MODERNIZATION AT CURRAN MIDDLE SCHOOL FOR:

BAKERSFIELD CITY SCHOOL DISTRICT

INTERIOR ELEV.
BUILDINGS C, R1A-R
R3A; R6B-R6E; R7A-R

A-2313

D1 WOMEN'S R/R C-107

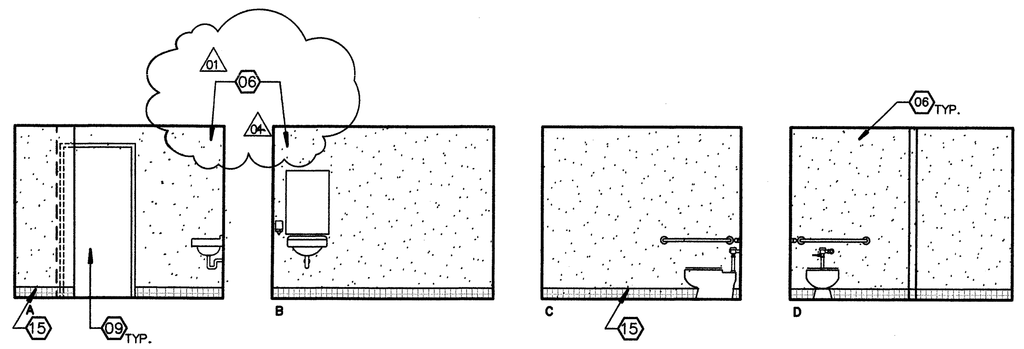
Item No. 21: Refer to Sheet A-2313
Interior Elevation "D1", Elevations "A" & "B" Keynote #6 incorrect, revise to read. "#08." Interior Elevation "D3", Elevations "C" Delete Keynote #02; Elevation "D" Sink cabinet to be made accessible, replace existing sink cabinets with (WIC 155) all references to sink cabinet modification to be deleted. Interior Elevation "C4", Elevations "C" Delete Keynote #02; Elevation "D" Delete Keynote #02 at upper cabinets and sink cabinet to be made accessible, replace existing sink cabinets with (WIC 155) all references to sink cabinet modification to be deleted. Interior Elevation "B1", Elevation "A" & "C" Keynote #02 is to reference lower cabinets and Keynote #04 is to reference upper cabinets. Elevation "C" sink cabinet to be made accessible, replace existing sink cabinets with (WIC 155) all references to sink cabinet modification to be deleted. Interior Elevation "A1", Elevation "A" & "C" Keynote #02 is to reference lower cabinets and Keynote #04 is to reference upper cabinets. Elevation "C" sink cabinet to be made accessible, replace existing sink cabinets with (WIC 155) all references to sink cabinet modification to be deleted. Revise Keynote #02 to read. "Remove and replace existing counter top with corian countertop with 6" splash (unless noted otherwise) caik to wall typical." Revise Keynote 03 to read. "Replace existing sink cabinet with ADA compliant sink cabinet, typical all sink cabinets." Revise Keynote #4 to read. "Existing cabinet to remain, remove and replace all doors, drawer fronts, & face plates. Finish per specifications." Revise Keynote #15 to read. "Provide new corian countertop see detail E4 sheet A-501."
